ACCESS PERMIT APPLICATION

Application Date: 01-21-20 Physical Address of Property: 640 PALMER LANE

Description of Project: DRIVEWAY Is property in floodplain? NO

Sketch Plan:

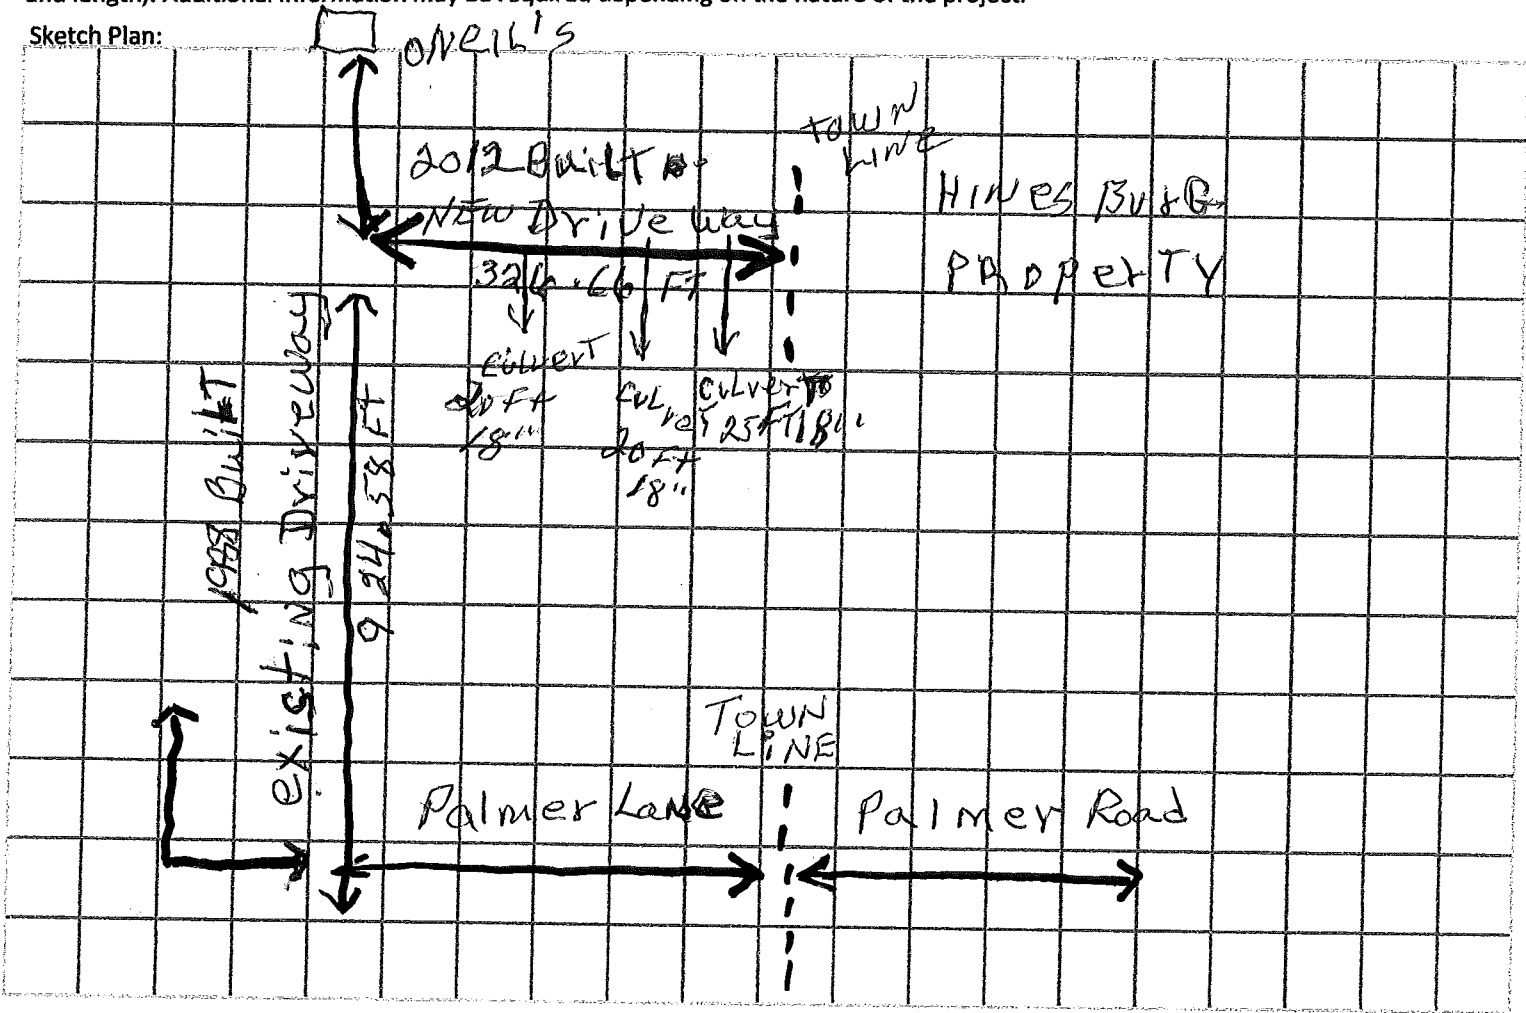
Comments: NO SIGHTLINE OR ACCESS ISSUES Additional comments on reverse

Application received & reviewed by Highway Department (date): 1-27-21 Decision: APPROVED DENIED / WITHDRAWN
